**RE: The Varela Residence Volcano Cliffs Unit 18
6505 Pato Rd NW, S.A.D. 228, Lot 21 Block 6
Grading and Drainage Plan Date 12/27/16 (D10D003M21)
Pad Certification Date 1/25/17
CO Approval Date 6/2/2020
Revised G&D plan for pool Date: 3/20/2023**

Based upon the information provided in your submittal received 3/23/2023, this plan for Certificate of Occupancy cannot be approved until the following comment is addressed.

DRAINAGE AND TRANSPORTATION INFORMATION SHEET (REV 11/2018)

GRADING
PLAN

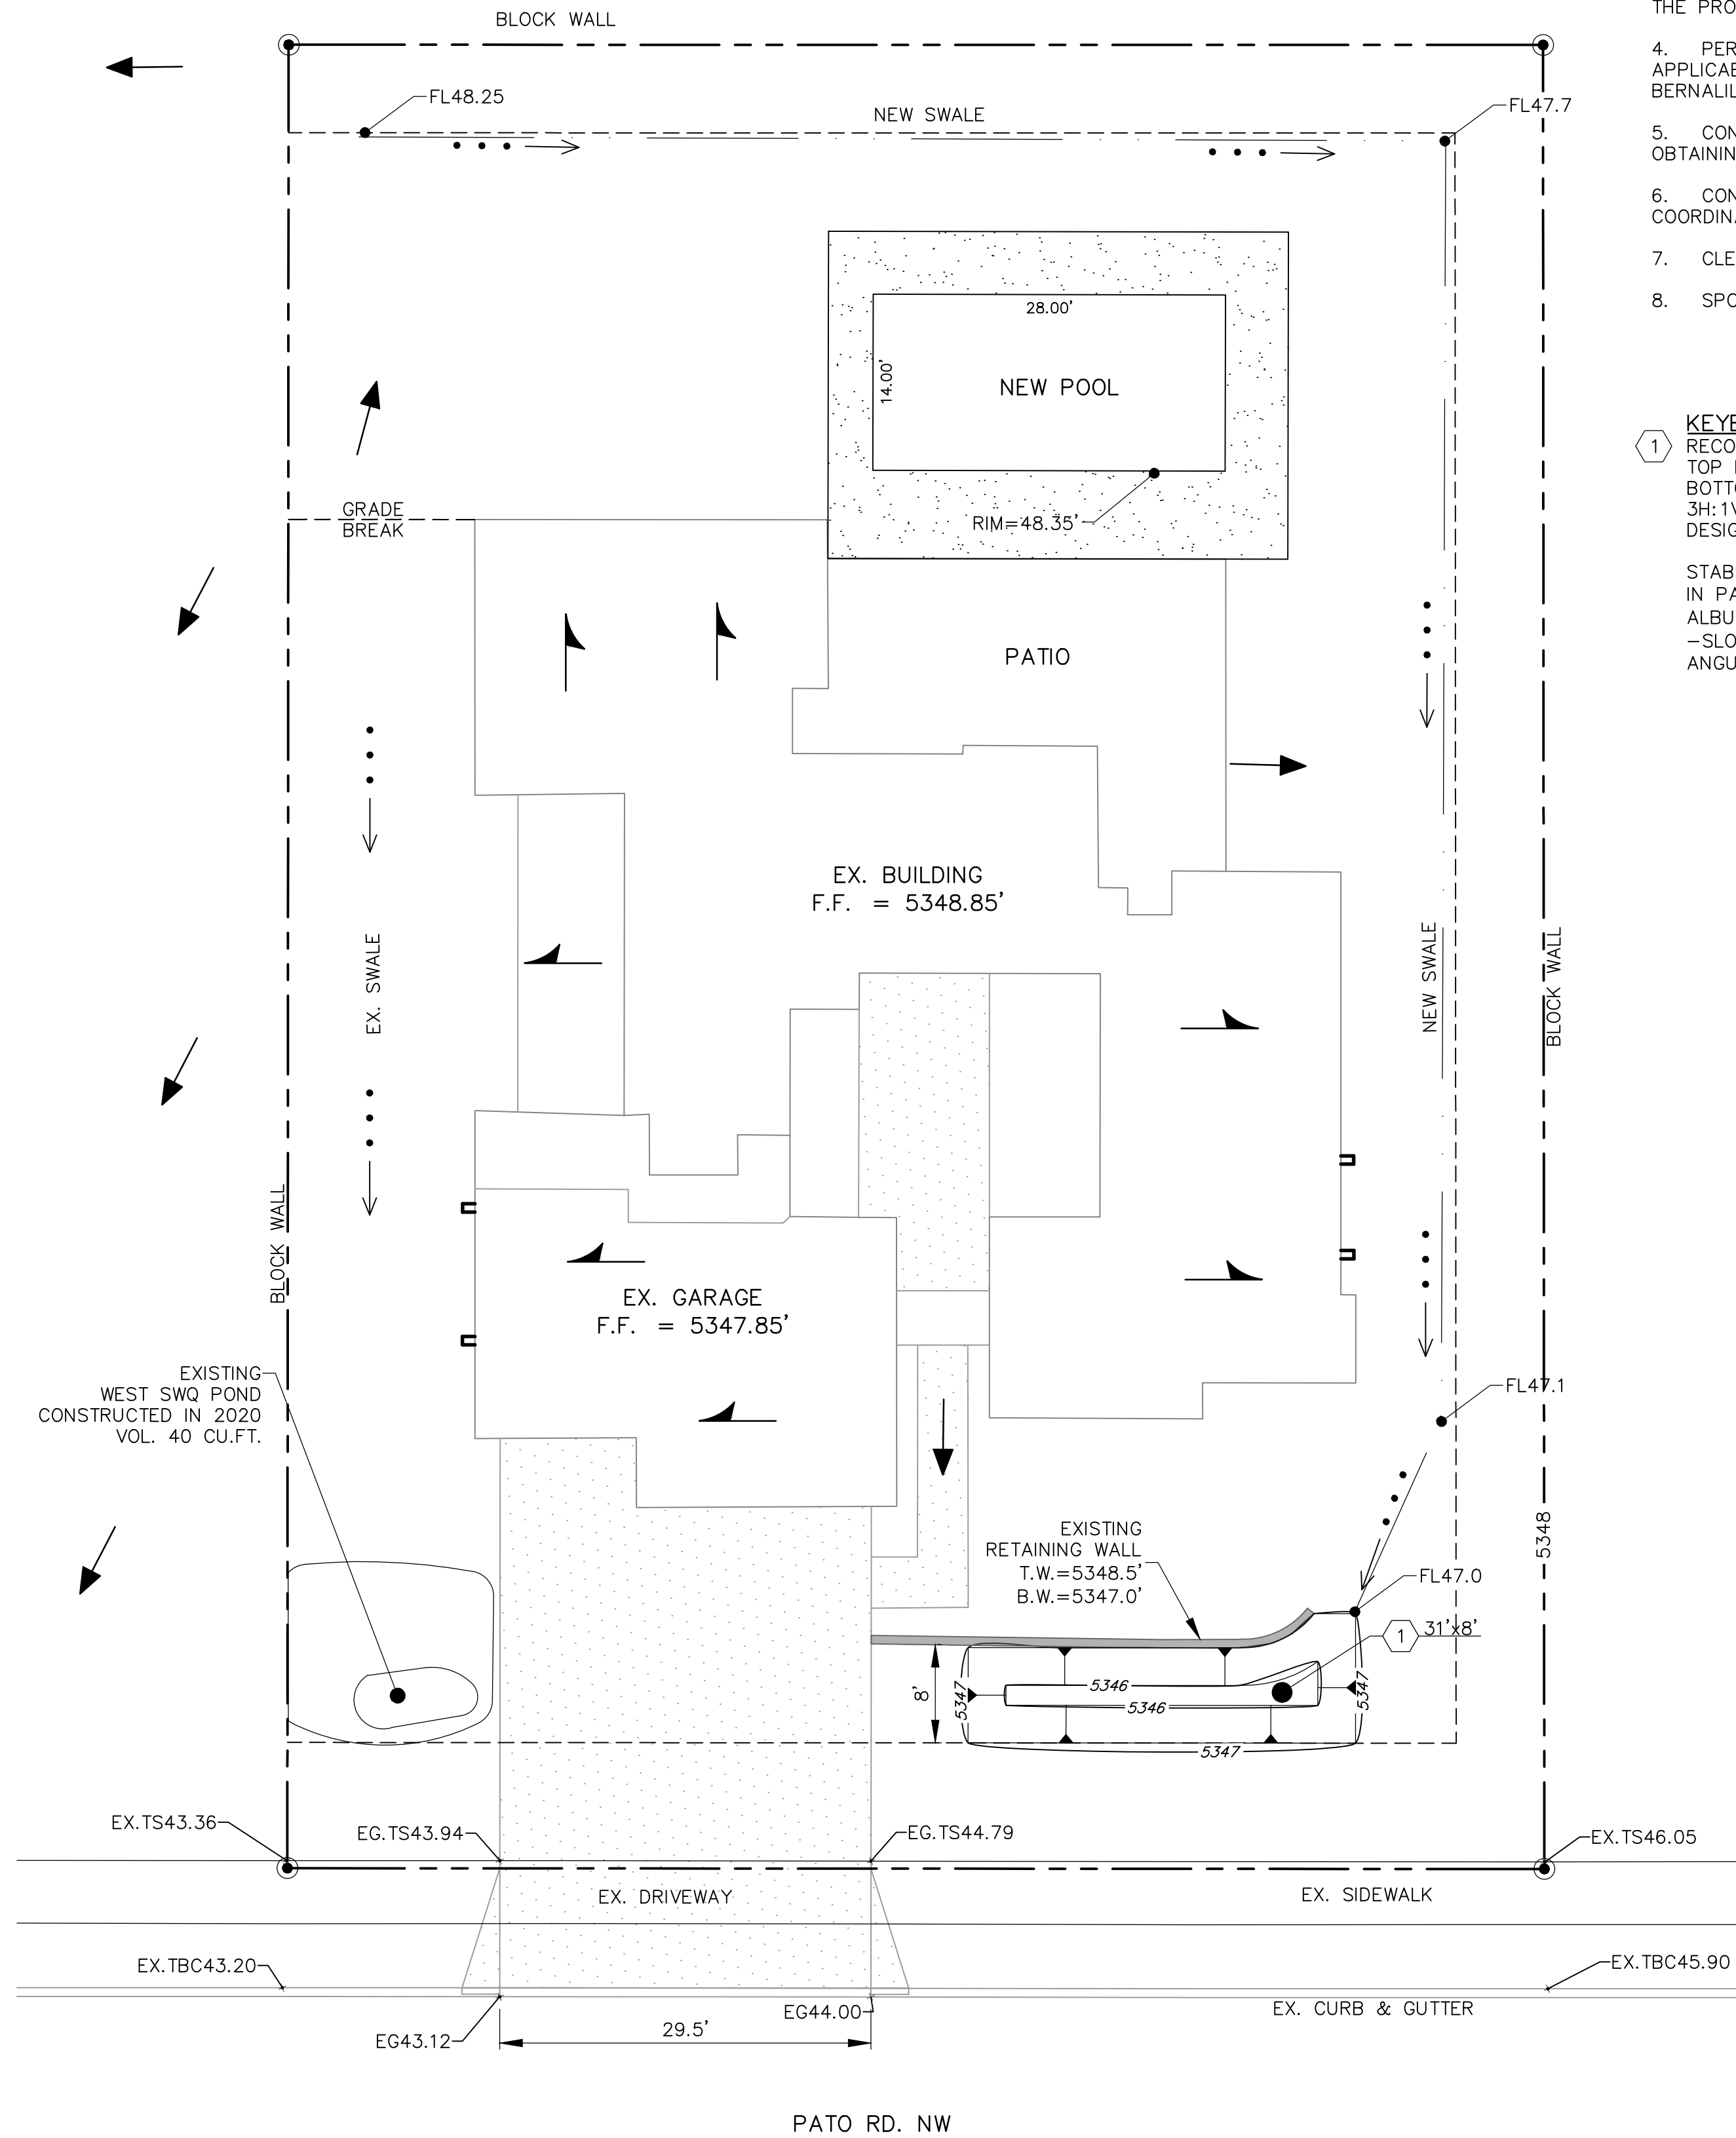
- Provide new land treatment amounts.
- Provide new pond size if needed.
